# City of Santa Fe, New Mexico

# memo

**2024-009650-HDRB, 202 Irvine St.,** Westside-Guadalupe Historic District, Non-contributing. Michael Bodelson, agent for Charles Rennick, owner, proposes to construct two closet additions on the east façade for a total of 125 sq. ft., relocate one window on the south façade, raise the chimney height to 11'-1" where the maximum allowable height is 12'-7", and requests an exception to 14-5.2(I)(1)(a) to allow wood as an exterior wall material for an existing shed.

**PROPOSED EAST ELEVATION**

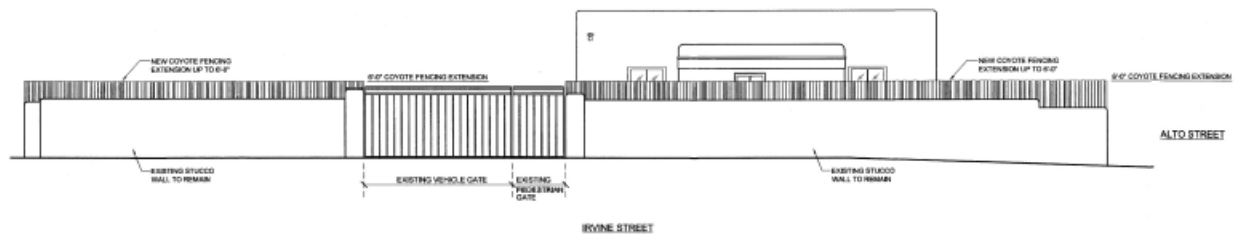
- 1) Construct two (2) small closet additions on the east façade.
- 2) Relocate one (1) window on the south façade.
- 3) Convert a wood stove to a gas-log fireplace and remodel the chimney on the southwest corner of the structure.
- 4) Approval for an 8’ by 24’, pre-existing, non-conforming blue wooden storage shed at the southwest corner of the property which will be relocated to meet accessory structure setback requirements.

Staff recommends approval of the proposed project and finds that the exception criteria has been met, and the application complies with Section 14-5.2(D) General Design Standards for all Historic Districts, and 14-5.2(I) Westside-Guadalupe Historic District Design Standards.
